# Concerning Comments r03-21, -22, -42, -43 On TDECQ

20180709

P802.3cd

# (1) 50G-PAM4 DML Measurements

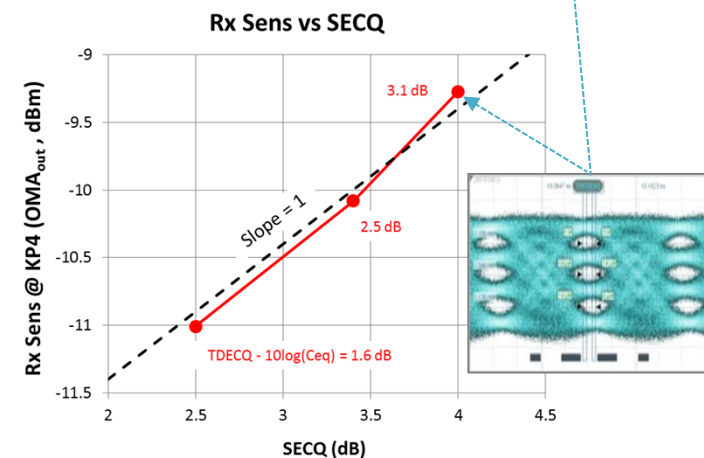
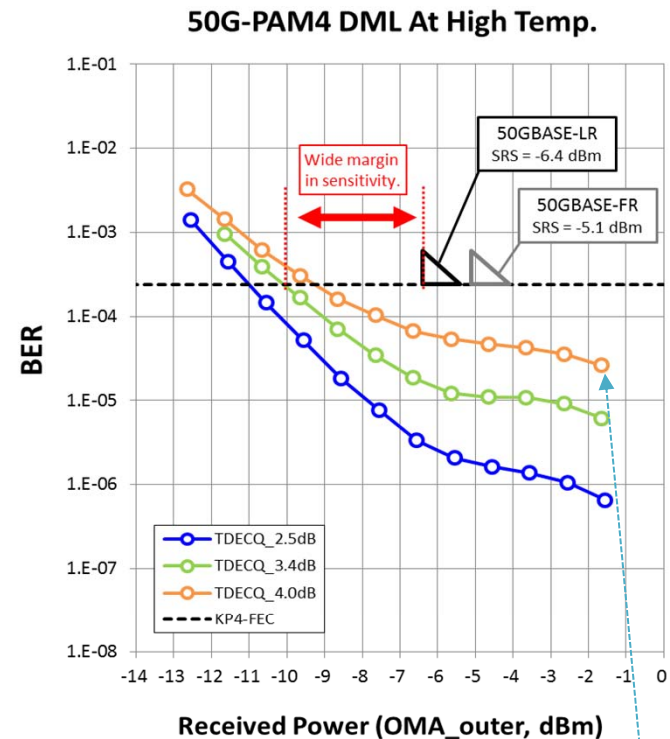
1. Rx Sensitivity vs SECQ has slope ~1.
2. Rx Sensitivity << SRS spec even for SECQ of 4 dB.

1. **D3.2 values for TDECQ (max) of 3.2 dB/3.4 dB for 50GBASE-FR/LR are reasonable.**
2. **TDECQ (max) of 3 dB/3.2 dB acceptable.**

# (2) 50G-PAM4 DML Measurements

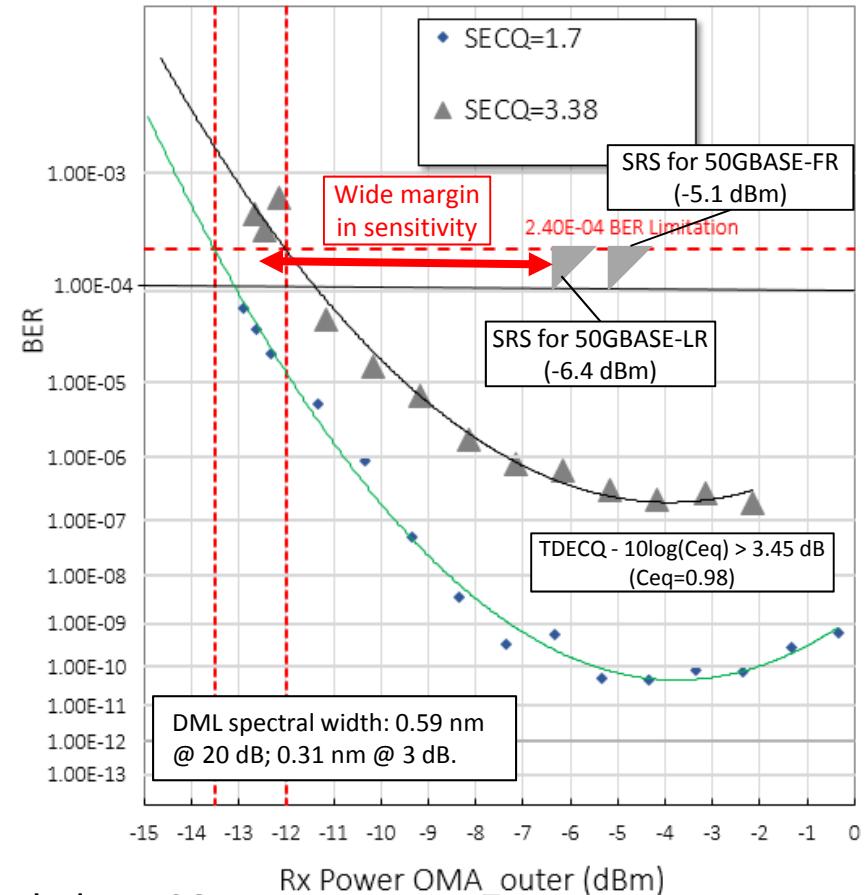
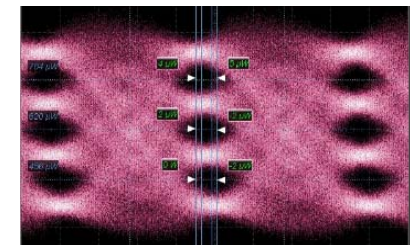
1. BER floor and Rx Sens are good, despite skew-degraded TDECQ.
2. Rx Sensitivity << SRS requirement even for TDECQ > 3.4 dB.
3. BER floor << 2.4E-4 even for TDECQ > 3.4 dB.

1. **D3.2 values for TDECQ (max) desirable for DML for 50GBASE-FR/LR.**
2. **TDECQ (max) of 3 dB/3.2 dB acceptable.**

# (1) 100G-PAM4 EML Measurements

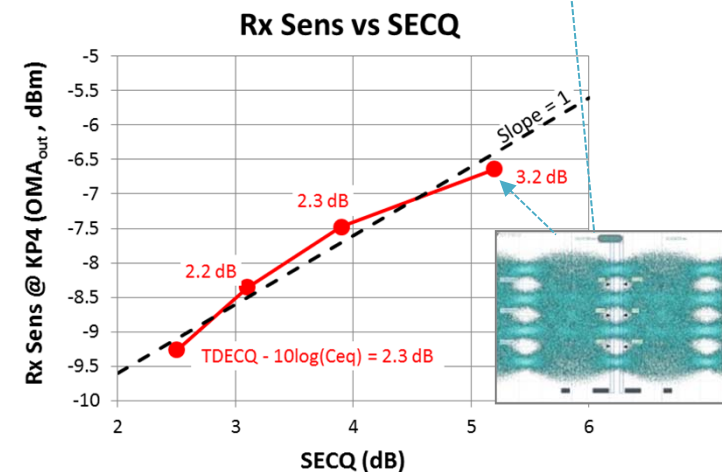
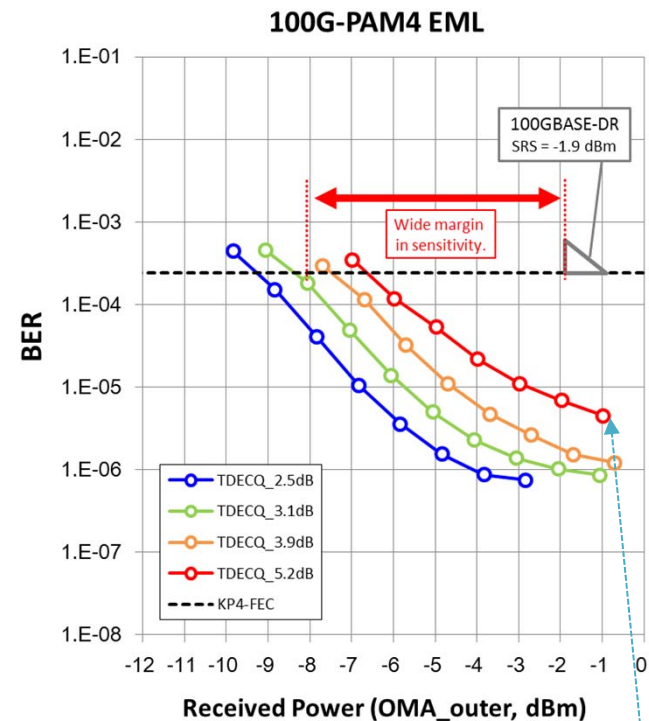
1. Rx Sensitivity vs SECQ has slope  $\sim 1$ .
2. Rx Sensitivity  $\ll$  SRS spec for SECQ of 5.2 dB.

1. **D3.2 value of TDECQ (max) of 3.4 dB is reasonable for 100GBASE-DR.**

# (2) 100G-PAM4 EML Measurements

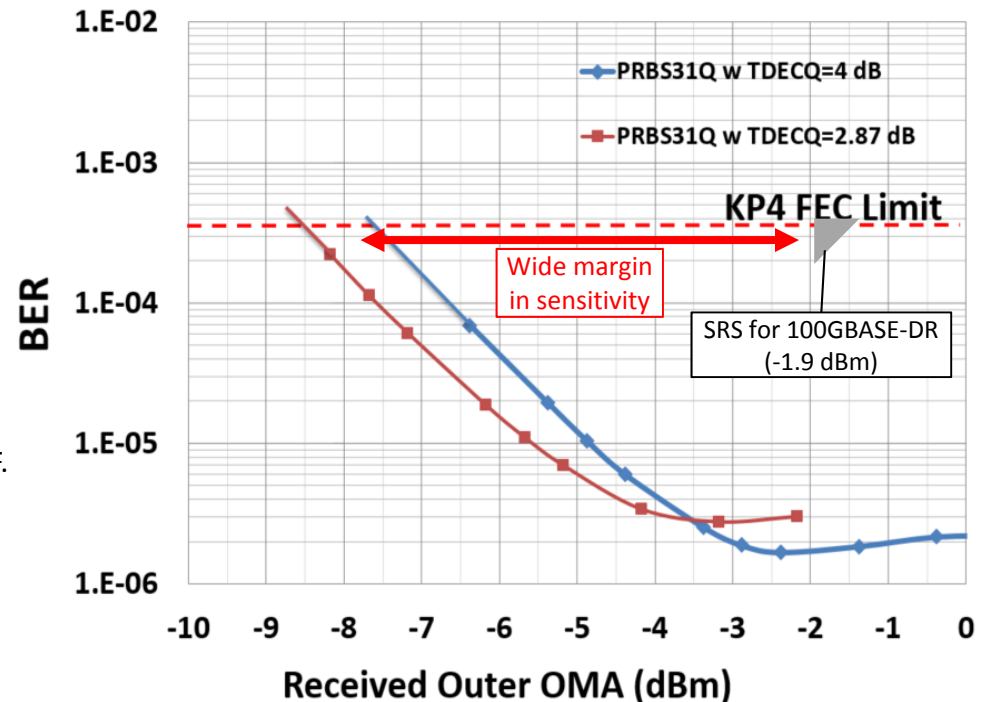
1. Sensitivity correlates with TDECQ
2. Rx Sensitivity << SRS specification for TDECQ >3.4 dB.

1. **D3.2 value for TDECQ (max) of 3.4 dB reasonable for 100GBASE-DR.**

# Consideration Of TDECQ - $10\log_{10}(\text{Ceq})$

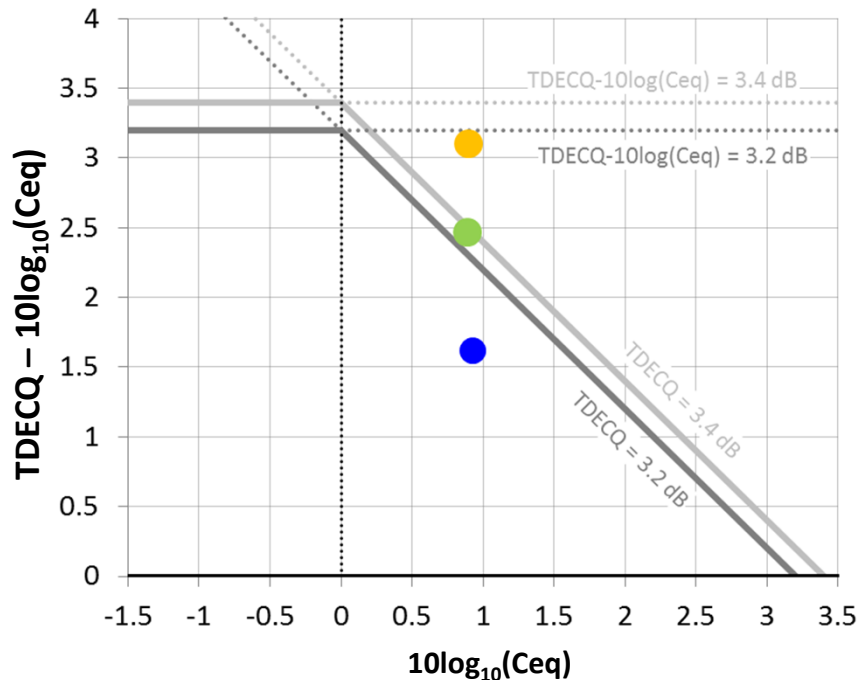
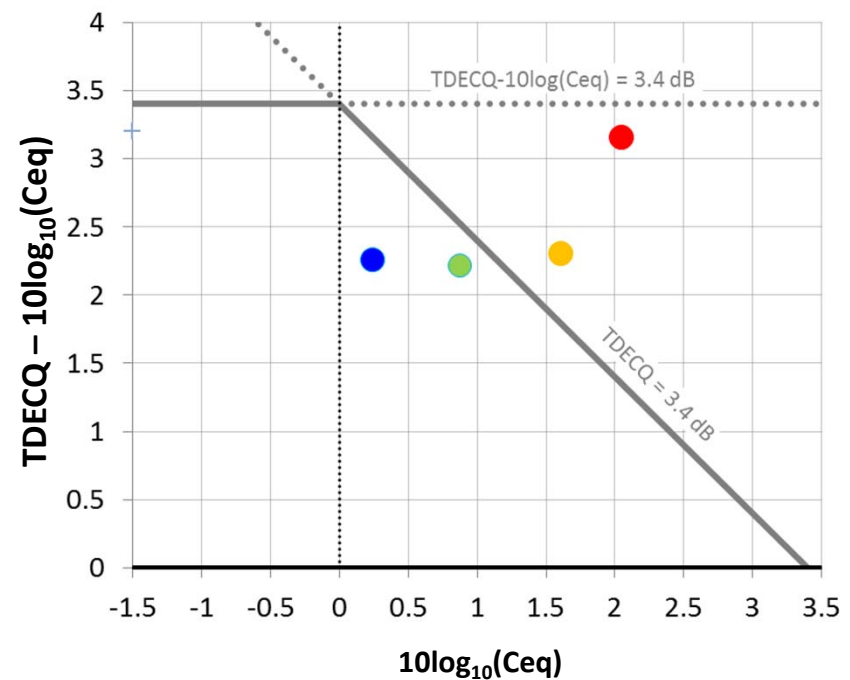
1.  $\text{TDECQ} - 10\log_{10}(\text{Ceq}) < \text{TDECQ}(\text{max})$  is one way to exclude cases where higher error floor was observed, though, for DML, case shown in green screened out by just  $\text{TDECQ}(\text{max})$  of 3.2 dB.
